Product Change Notice (PCN)

PCN Number: **PCN-0456749R-01**

Product(s) Affected: *MJ-2508*

| PREVIOUS CUI DEVICES DETAIL / IMAGE | NEW CUI DEVICES DETAIL / IMAGE |

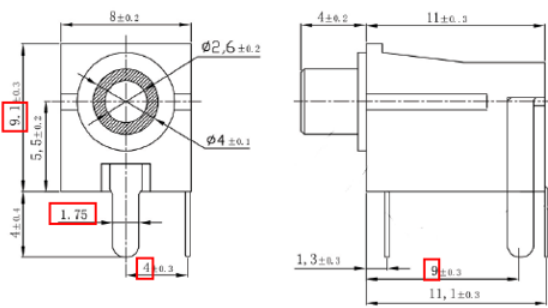
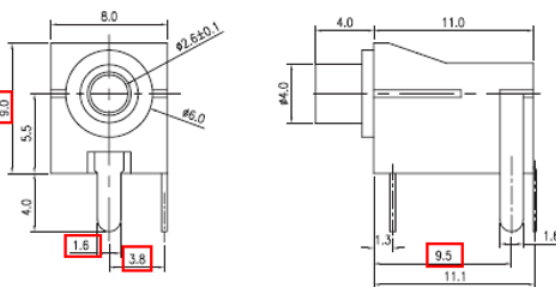
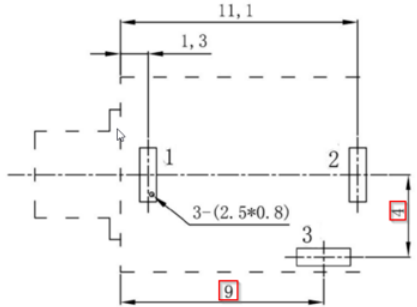
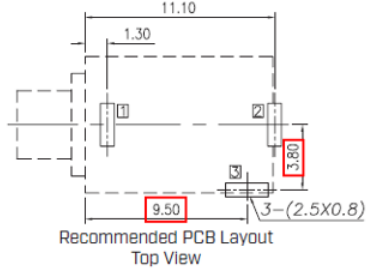
Description of Change: *New Factory Location. Product re-engineered for improved manufacturability and production yield. See image below for reference and check CUI Devices website for updated drawing on or after 09/10/2024. Cosmetic differences may be visible and not affect the form fit and function of the product*

| PREVIOUS CUI DEVICE'S DETAIL / IMAGE | | | NEW CUI DEVICE'S DETAIL / IMAGE | | |
|--------------------------------------|---------------|---------------|---------------------------------|------------------------|-----------------|
| terminal 1 | brass | tin | terminal 1 | brass t-0.40 | tin over nickel |
| terminal 2 | brass | tin | terminal 2 | phosphor bronze t-0.20 | tin over nickel |
| terminal 3 | brass | tin | terminal 3 | brass t-0.40 | tin over nickel |
| bushing | brass | tin | bushing | copper alloy | nickel |
